Office Action Summary	Application No. 10/715,164	Applicant(s) WATSON, RICHARD	
	Examiner Michael G. Bogart	Art Unit 3761

DETAILED ACTION

7. Claims 21-23, 25, 26, 29-34 and 37-47 are rejected under 35 U.S.C. § 103(a) as being unpatentable over Hunt *et al.* (GB 2 307 180 A; hereinafter: "Hunt") in view of Maher *et al.* (US

Fig. 1

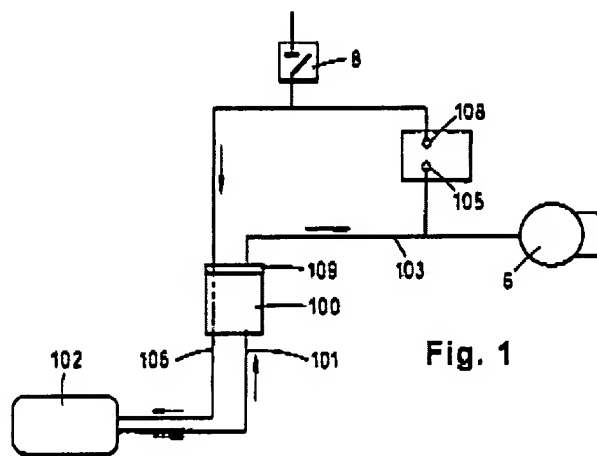
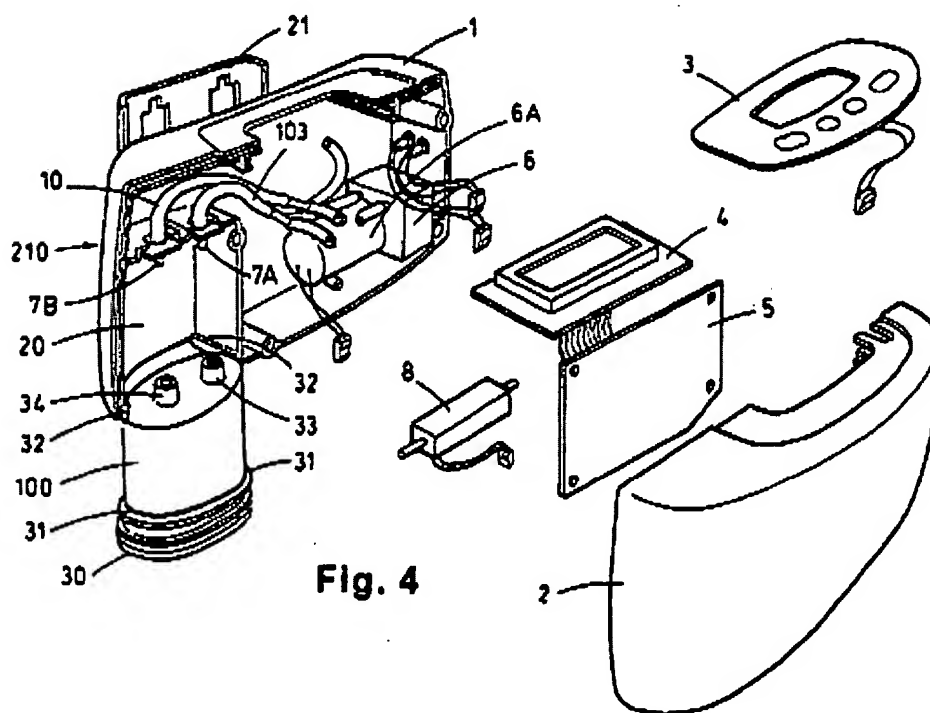
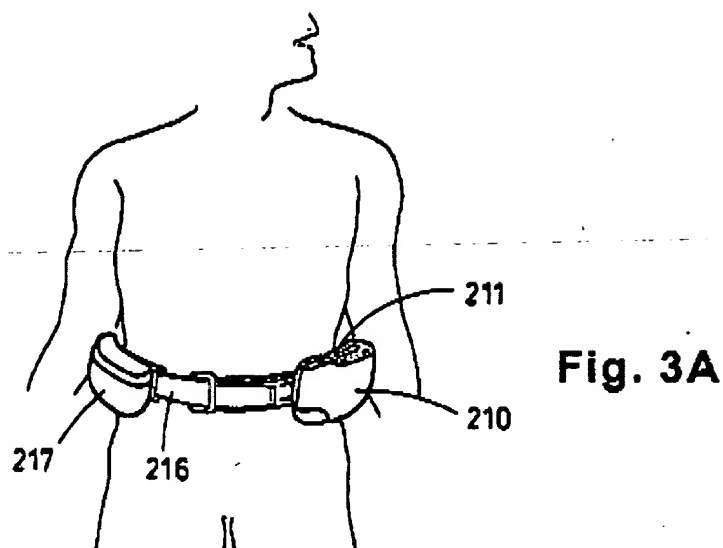
8. Regarding claims 21, and 41-44, Hunt teaches a personally portable vacuum desiccator (210) for collecting and storing liquid-exudate comprising:

a cartridge (100) having an interior chamber, inlet and outlet ports (32, 33);

a vacuum pump member (6) in gas/liquid communication (103) with the outlet port (33) of the chamber;

a motor (6A) operably connected to said vacuum pump (6); and

a tube (106) having a first end in fluid communication the inlet port (32)(100)(see figures 1, 3A and 4, *infra*).

Hunt thus teaches the claimed invention except for the trapping agent in the chamber, the planar battery shape and the unidirectional inlet port.

FIG. 5

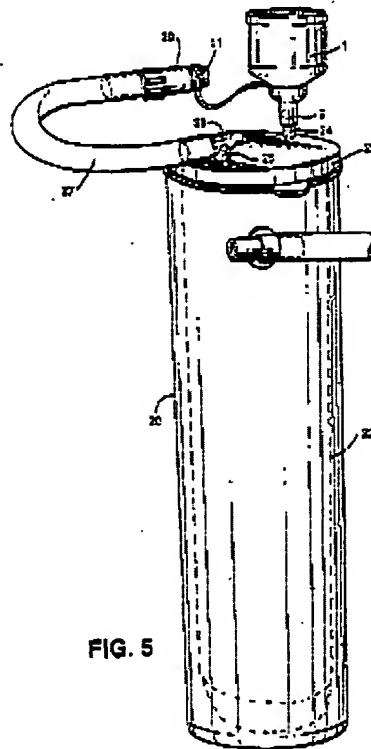
Maier teaches a bodily fluid collect receptacle (20) to which an absorbent gelling treatment is added to the interior thereof to solidify liquid exudates. This avoids hazards associated with spillage (abstract)(see fig. 5, infra).

FIG. 1

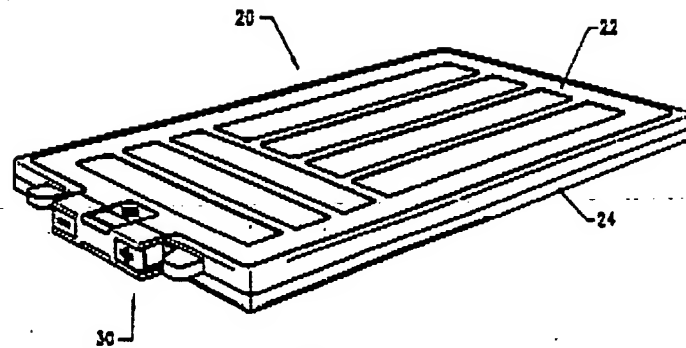
Aldecoa teaches a slim planar battery (20) that is shaped for insertion into compact personal electronic devices (abstract)(see fig. 1, infra).

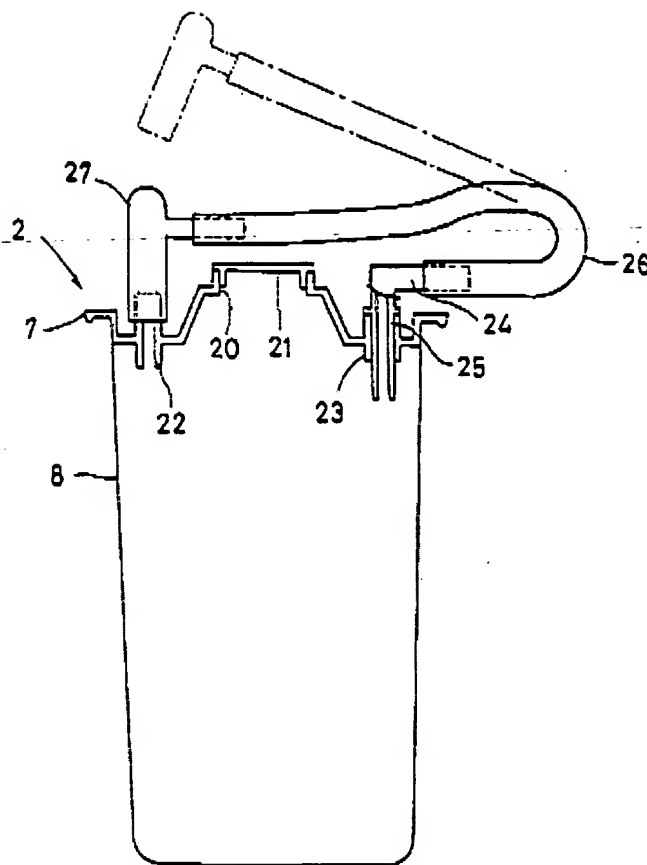
Ohira teaches a one-way check valve in entrance port (22). This prevents unwanted reverse flow of liquid out of the container (col. 13, lines 42-49)(see fig. 2, infra).

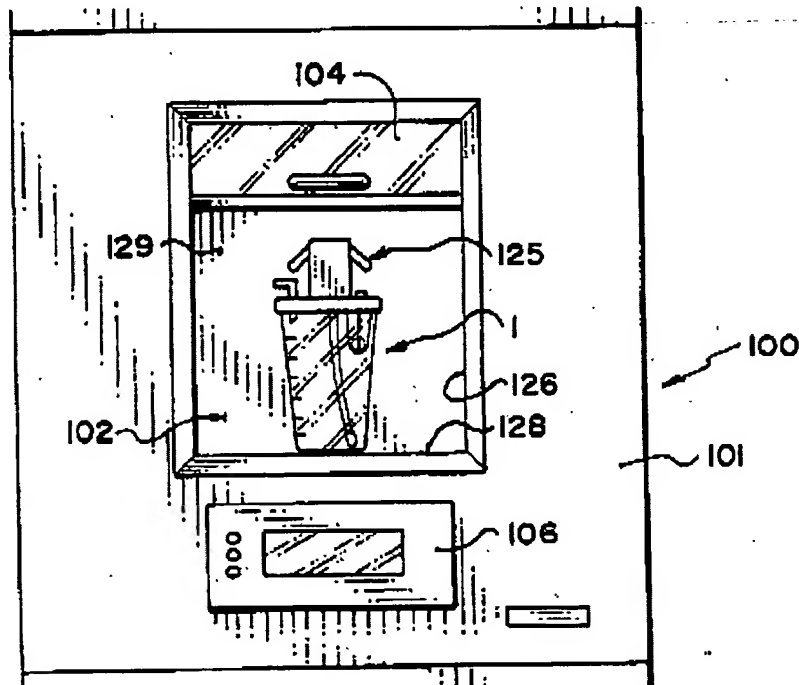
Hunt, Maher, Aldecoa and Ohira do not teach an I/O unit.

Lichtenstein teaches an automated medical care system that employs a pressure sensor (PS2) and an I/O circuit (101). At the time of the invention, it would have been obvious to one of ordinary skill in the art to add these elements to the device of Hunt, Maher, Aldecoa and Ohira in order to automate its functions. See *In re Venner*, 262 F.2d 91, 95, 120 USPQ 193, 194 (CCPA 1958) (Appellant argued that claims to a permanent mold casting apparatus for molding trunk pistons were allowable over the prior art because the claimed invention combined "old permanent-mold structures together with a timer and solenoid which automatically actuates the known pressure valve system to release the inner core after a predetermined time has elapsed." The court held that broadly providing an automatic or mechanical means to replace a manual activity which accomplished the same result is not sufficient to distinguish over the prior art.). MPEP § 2144.04 (III).
